Our File ST-123-10-A
August 30, 2010

Re: Strata Plan BCS 3187 – Viridian Green
1961 Collingwood Street, Vancouver, BC
- 2-Year Building Envelope Warranty Review

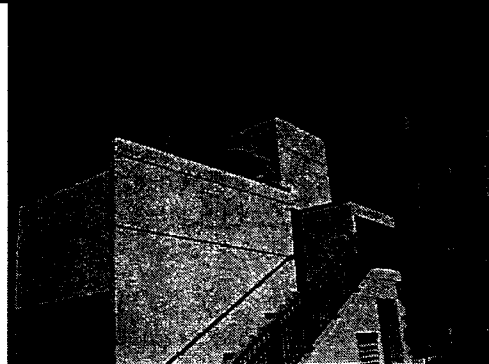
<p>3.1.8</p>	<p>OBSERVATION The joint between the brick cladding and the penetrating pipe appeared improperly sealed in reviewed location.</p> <p>RECOMMENDATION Properly designed sealant joints should be applied at all cladding penetrations including the one shown on the attached photo. (Warranty)</p>	
<p>3.1.9</p>	<p>OBSERVATION Debonding and/or lack of sealant joint at the mortar sealant interface was observed at few locations and was also reported to us by one of the Owners.</p> <p>RECOMMENDATION New sealant joints must be applied at locations where sealant has failed and/or is missing. (Warranty/Maintenance)</p>	
<p>3.1.10</p>	<p>OBSERVATION Staining and water pooling was observed on the exterior stairwell and at the base of the stair wall. It appears that water ingress occurs either at the top of the wall and/or at the gum lip detail.</p> <p>RECOMMENDATION Further investigation of the causes of the staining and pooling water is recommended. Detailing at the top of the wall including saddle detail of wall interfaces should be protected from water ingress. (Warranty/Maintenance)</p>

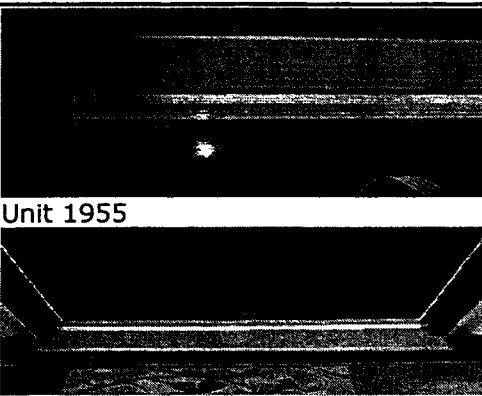
3.1.17	<p>OBSERVATION Staining and moisture-damaged drywall and baseboard was observed at Unit 1957.</p> <p>RECOMMENDATION Units experiencing condensation problems and elevated RH should be further investigated by Mechanical Consultant to ensure that the ventilation system (kitchen, bathroom fans) is working properly and that there is no accumulation of water in the wall assembly as a result of condensation. The moisture-damaged drywall and baseboards should be repaired. (Warranty)</p>	
--------	---	--
